**CITY OF TEMPE
DEVELOPMENT REVIEW COMMISSION**

Meeting Date: 06/09/2015
Agenda Item: 7

ACTION: Request for an Amended Planned Area Development and a Development Plan Review consisting of eighteen single-family attached townhomes for TEMPE PARKVIEW TOWNHOMES, located at 1937 East Don Carlos Drive. The applicant is Tana Nichols, Habitat for Humanity.

Job No.
140901
 SH. 1
 OF 1
 SITE PLAN 100

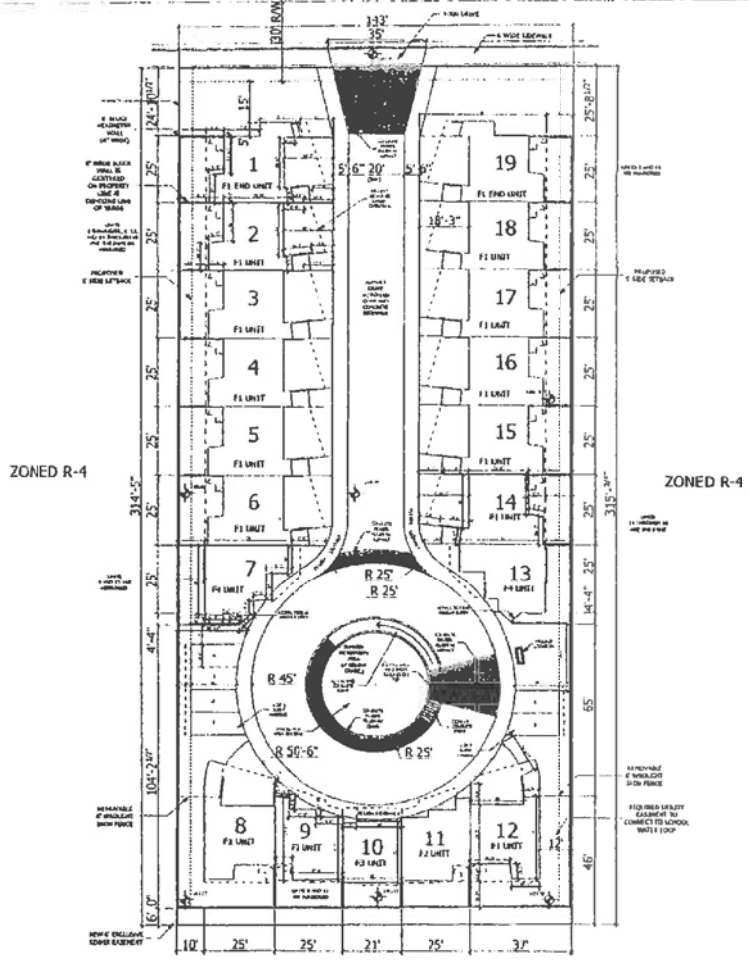
2. Provide 5'-6" wide public sidewalk along Don Carlos Avenue as required by Traffic Engineering Design Criteria and Standard Details.
3. Sign the private drive for no parking, fire lane.

4. Verify height of equipment and mounting base to ensure that wall height is adequate to fully screen the equipment. Locate electrical service entrance sections inside the back yard.

5. Provide gates of steel vertical picket, steel mesh, steel panel or similar construction. Where a gate has a screen function and is completely opaque, provide vision portals for visual surveillance. Provide gates of height that match that of the adjacent enclosure walls. Review gate hardware with Building Safety and Fire staff and design gate to resolve lock and emergency ingress/egress features that may be required.

6. Provide upgraded paving at the private drive entrance from Don Carlos consisting of unit paving Extend this paving in the driveway from the right-of-way line to 20'-0" on site and from curb to curb at the drive edges. From sidewalk to right-of-way line, extend concrete paving to match sidewalk.

LANDSCAPE PLAN
TEMPE PARKVIEW TOWNHOMES
1937 EAST DON CARLOS AVENUE
TEMPE, AZ

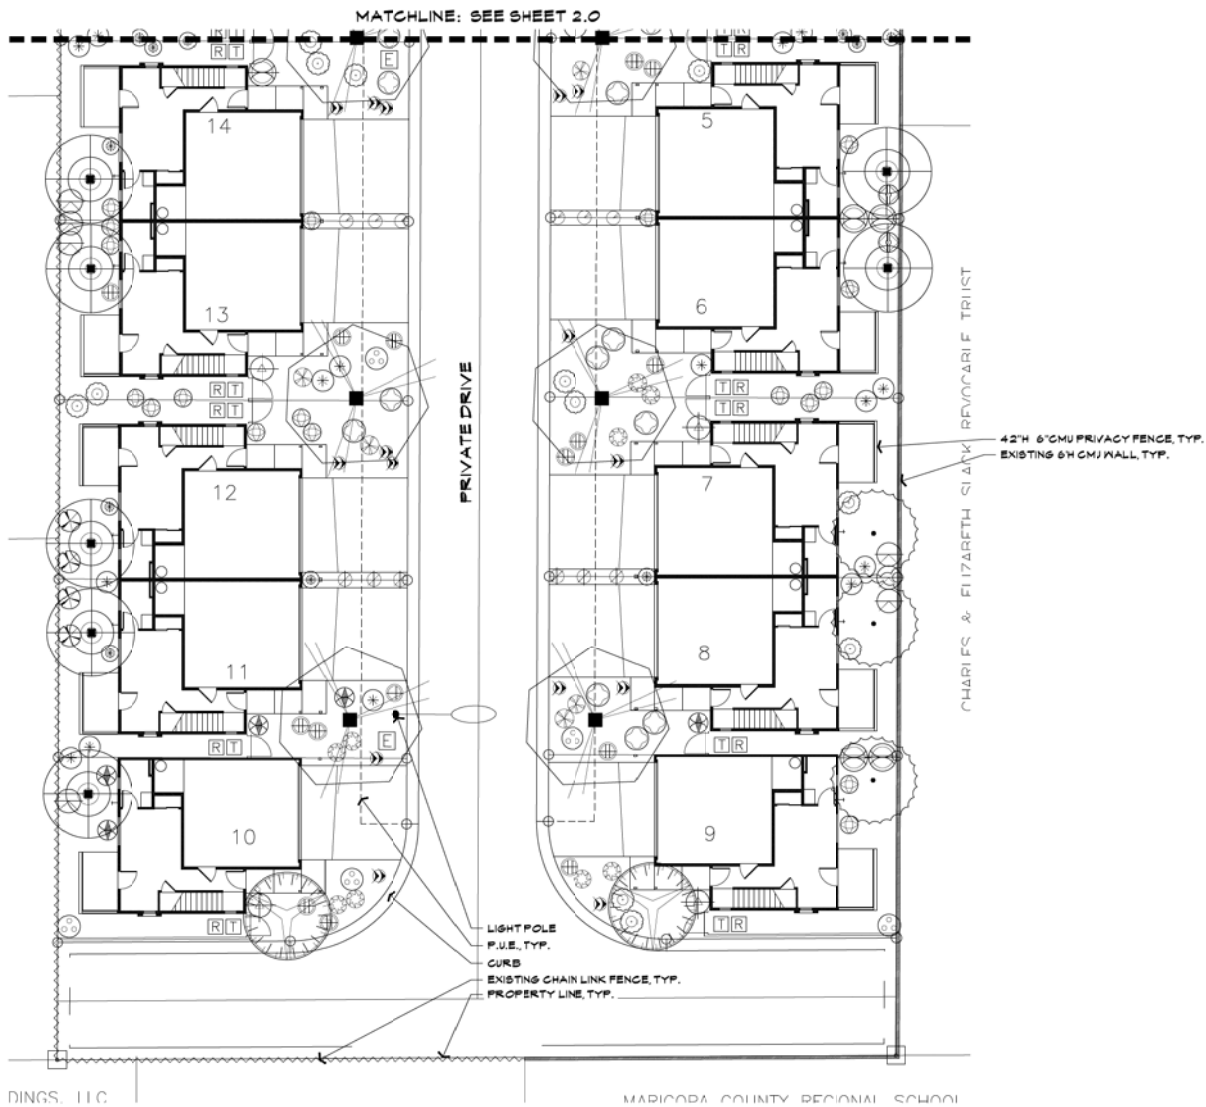
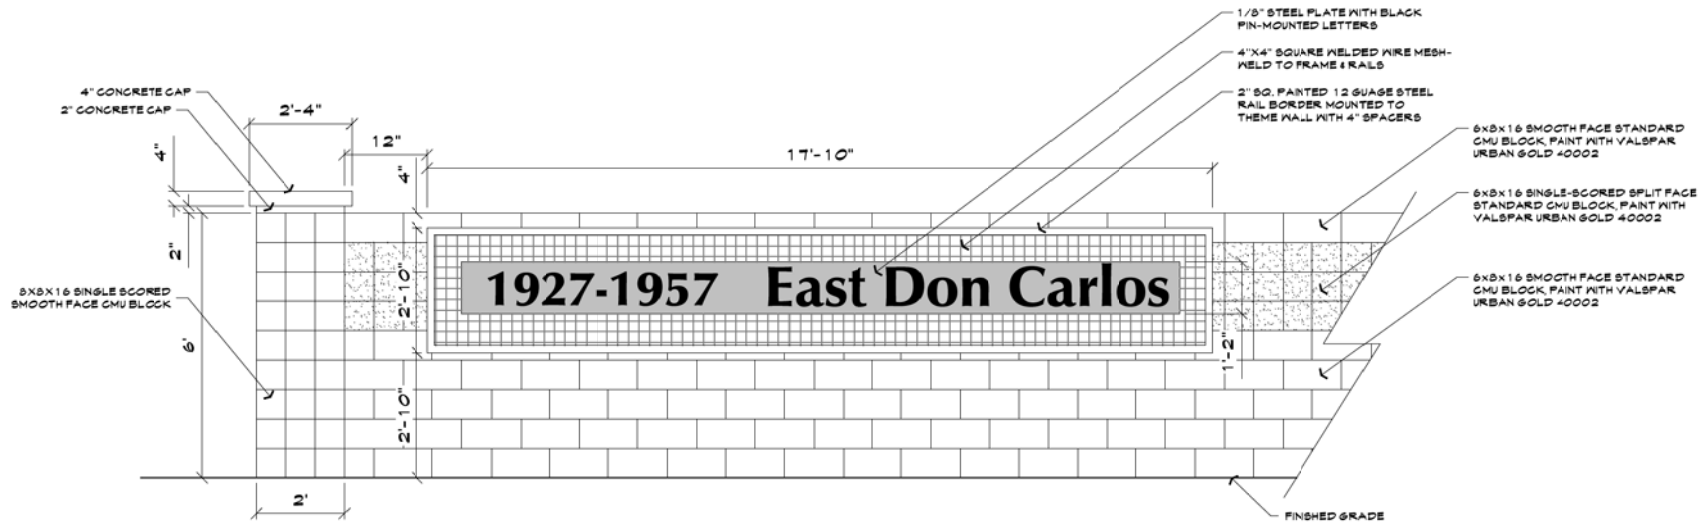
15. The plant palette is approved as proposed and specified on the landscape plan. Any additions or modifications may be submitted for review during building plan check process.
16. Irrigation notes:
 - a. Provide dedicated landscape water meter.
 - b. Provide pipe distribution system of buried rigid (polyvinylchloride), not flexible (polyethylene). Use of schedule 40 PVC mainline and class 315 PVC ½" feeder line is acceptable. Class 200 PVC feeder line may be used for sizes greater than ½". Provide details of water distribution system.
 - c. Locate valve controller in a vandal resistant housing.
 - d. Hardwire power source to controller (a receptacle connection is not allowed).
 - e. Controller valve wire conduit may be exposed if the controller remains in the mechanical yard.

17. Include requirement to de-compact soil in planting areas on site and in public right of way and remove construction debris from planting areas prior to landscape installation.

18. Top dress planting areas with a rock or decomposed granite application. Provide rock or decomposed granite of 2" uniform thickness. Provide pre-emergence weed control application and do not underlay rock or decomposed granite application with plastic.

19. Trees shall be planted a minimum of 20'-0" from any existing or proposed public water or sewer lines. The tree planting separation requirements may be reduced from the waterline upon the installation of a linear root barrier, a minimum of 6'-0" parallel from the waterline, or around the tree. The root barrier shall be a continuous material, a minimum of 0.08" thick, installed 0'-2" above finish grade to a depth of 8'-0" below grade. Final approval subject to determination by the Public Works, Water Utilities Division.
